# RH-TRU 72-B Packaging

## RH-TRU 72-B SAR Revision 5 Amendment Request for Supplemental Information dated November 4, 2010

Presented to the US Nuclear Regulatory Commission  
by Washington TRU Solutions on behalf of the US Department of Energy  
December 9, 2010

## ■ NS15 & NS30 (shown)

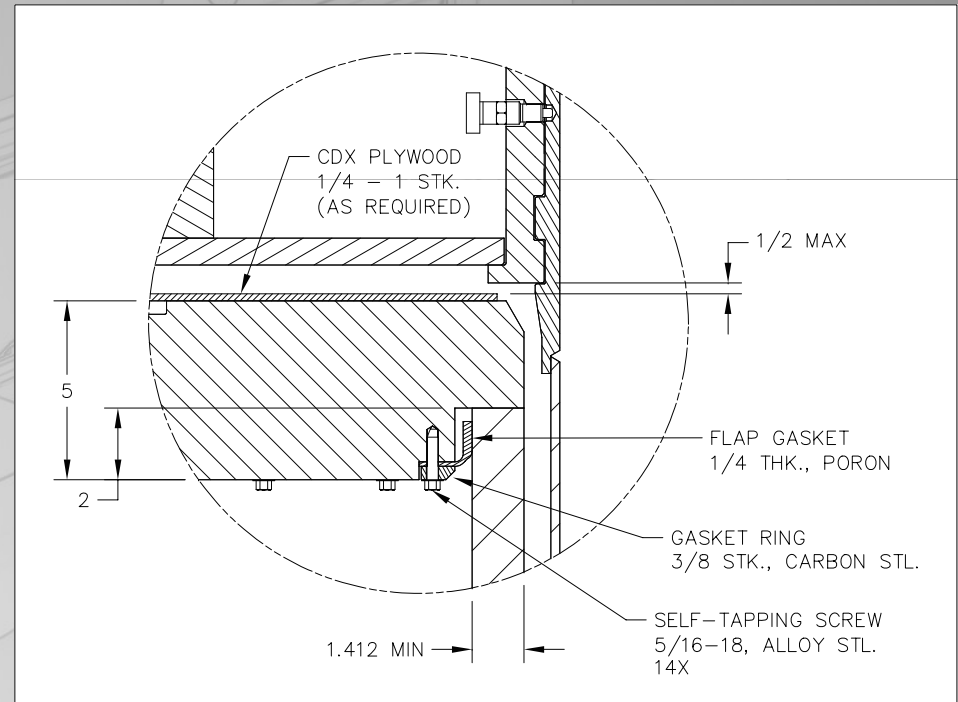
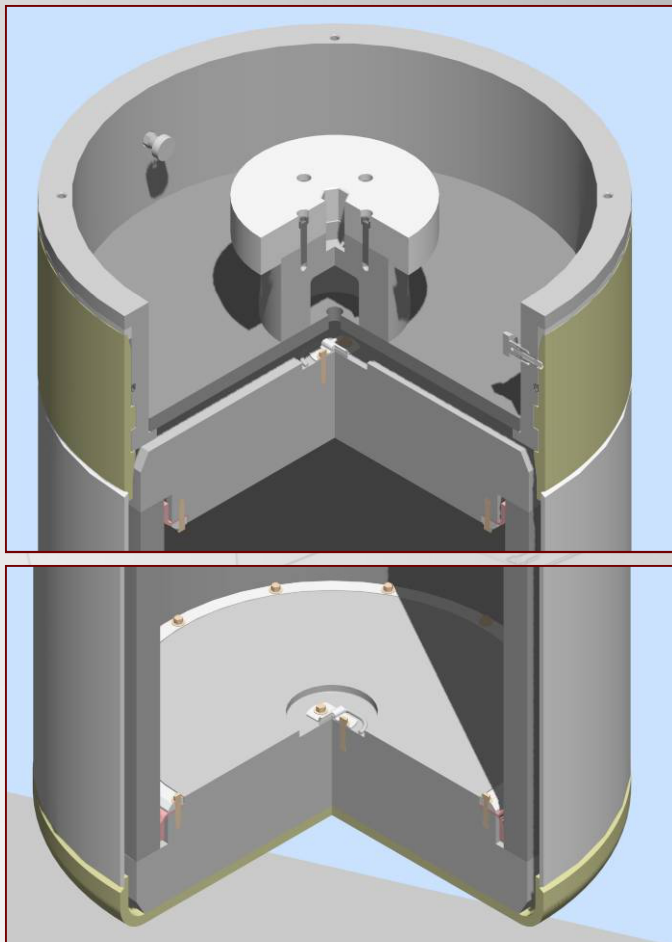
*Update the NS15 and NS30 thermal analyses presented in the Safety Analysis Report (SAR) to reflect the recently provided NCT and HAC thermal analyses.*

*The response from the Request for Additional Information (RAI) teleconference (9/27/10) provided three shielded NS15/NS30 thermal analyses that do not use bulk spatial and temporal-averaged insolation boundary conditions. As a result of the analyses, the applicant mentions that the RH-TRU 72-B SAR design decay heat limit will be changed from 300 W to 50 W per canister. In addition, the new modeling methodology and the higher temperatures of the components found as a result of the updated NS15 and NS30 analyses should be incorporated in the appropriate sections of the SAR, such as Appendix 5.1 of the RH-TRU Payload Appendices.*

*This information is requested by staff to determine compliance with 10 CFR 71.71 and 71.73.*

- Performed 2-D transient thermal with 400 W/m<sup>2</sup> insolation to all exposed external surfaces (NS15 Sensitivity A) to compare with SAR 2-D steady-state with 127 W/m<sup>2</sup> (Current SAR)

- all component temperatures remain well within the NCT allowable temperature limits
  - even with solar loads applied, the maximum external surface temperatures remain within the regulatory limits for exclusive-use shipments

- the NS15 shield insert maximum temperature remains less than its 150 °F design basis
  - all sensitivity analysis temperatures are below the current SAR 300-watt metallic waste case temperatures that are utilized to establish the bounding values for all hot temperature structural component evaluations

- hot foam structural evaluations are performed using a bulk average foam temperature of 140 °F, which remains above the bulk average foam temperature of 133 °F established by the sensitivity analysis

- Option 1 (preferred) – Rely on RSI response that documents the sensitivity analysis to demonstrate that the current SAR analyses are adequate to ensure safety because all limits are met even with the application of 400 W/m<sup>2</sup> insolation boundary conditions to all exposed external surfaces

- All shipments to date << 50 watts (1 @ 13.83 W, 93% < 1 W)
  - Shipments under the 300-watt case to be disallowed in the RH-TRAMPAC to ensure sensitivity results are bounded by existing 300-watt analysis

- SAR Chapter 3 revised under timely renewal process to formally incorporate currently accepted practice
- Option 2 – Revise SAR Chapter 3 to formalize a “currently accepted” application of insolation boundary conditions

- Propose consistency with IAEA guidance to apply a more reasonable insolation boundary condition of 400 W/m<sup>2</sup> on upward facing curved surfaces and 200 W/m<sup>2</sup> on downward facing curved surfaces

## ■ Bounding Configuration

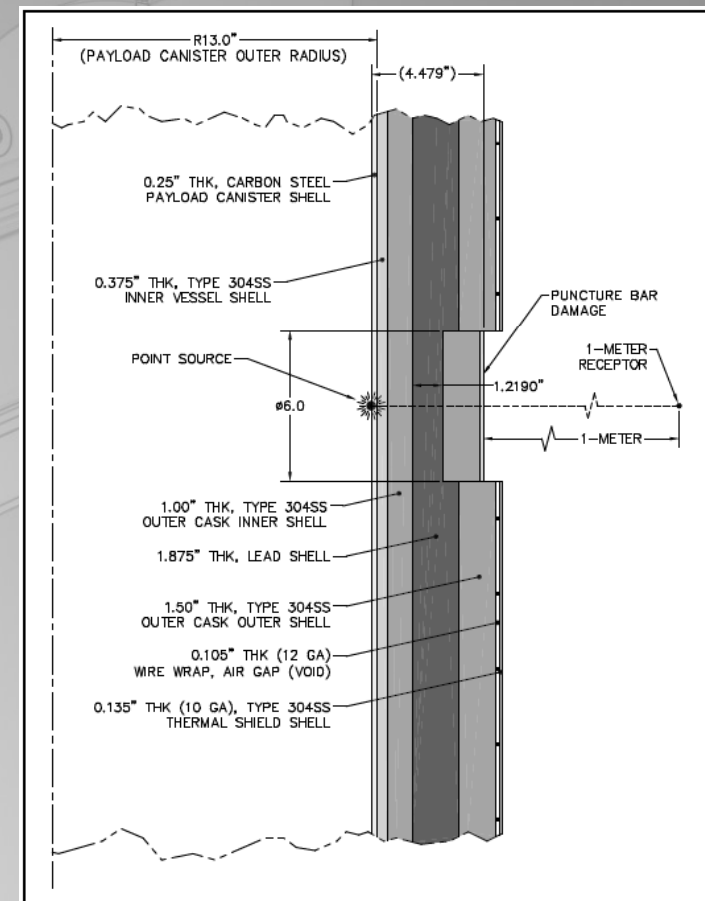
*Provide sufficient detail regarding the pre-shipment dose rate measurements and results of previous measurements to demonstrate the acceptability of this method, for the current amendment only, for use to meet the requirements of 10 CFR 71.35(a) and 71.47.*

*Per 10 CFR 71.35(a), an application for a Part 71 Certificate of Compliance (CoC) must include a demonstration that the package containing the proposed contents at the proposed quantity limits satisfies, among other things, the requirements in 10 CFR 71.47. The current amendment application seeks to use pre-shipment dose rate measurements to meet this requirement. While pre-shipment measurements are normally not accepted as fulfilling this requirement, they may be found acceptable in the current case for only the current amendment only with certain additional conditions and the provision of further information to justify that the package's compliance with 10 CFR 71.47 will be ensured for the proposed contents at the proposed quantities. Package operations descriptions in Chapter 7, "Package Operations," of the SAR should also be modified to incorporate (by reference is acceptable) these conditions.*

*The applicant has provided some information regarding performance of pre-shipment measurements; however, this information does not completely satisfy the RAI. In addition to the measurement descriptions currently provided by the applicant, descriptions should be included that explicitly state that the neutron and gamma dose rate measurements are performed on the package surface and at 2 meters from the package surface. This ensures clarity as to which surfaces are being referenced. A statement should be added that clearly states that both gamma and neutron dose rate measurements are always performed and that they are done with appropriate instruments of appropriate/adequate dose rate ranges. The descriptions should also include that a grid is established for the entire package surface with squares no larger than a few inches (4 inches for example) on a side, with measurements taken at every grid location. Similarly, a description of how the 2-meter dose rate measurements are/will be comprehensive is also needed.*

*To justify the use of measurements in this case, the applicant should provide the results of representative cases from the measurements performed on previous shipments under the current CoC. The information should demonstrate the comprehensive nature of the measurements.*

*The applicant should provide the maximum measured surface and 2-meter dose rates for the package radial side and axial end surfaces, the contents descriptions (including Curie quantity(ies) and the form of the contents) for each result case included in the information. Results should be provided that cover the range of contents forms that are (to be) shipped in the RH-TRU 72-B package. Also, if the cases are not for the maximum allowed Curie quantity(ies) of the radionuclides present in the given cases, the applicant should also provide an evaluation of the dose rates for a package containing the maximum allowed quantities. A conservative approach to this task would be to take the highest dose rate contributor (both for gamma sources and neutron sources) present in the particular case and scale up its quantity to the maximum allowed by the CoC. Then, because the NS15 and NS30 differ from the current waste canisters, justification should be provided as to why the supplied results are sufficient to demonstrate that the higher quantities in the NS15 and NS30 canisters will meet 71.47 limits. The justification should be quantitative as well as qualitative, noting effects of geometry and shielding differences between the proposed canisters and the currently approved canisters.*

- Each radionuclide individually analyzed under conditions of:
  - maximum shield damage (puncture)
  - minimum distribution/distance (point source aligned with puncture at inner surface of payload canister)
  - no credit for self-shielding
  - assume iron build-up factor for composite lead-steel shield
- Sum of partial fractions utilized to apply individual analyses to each unique mixture of radionuclides
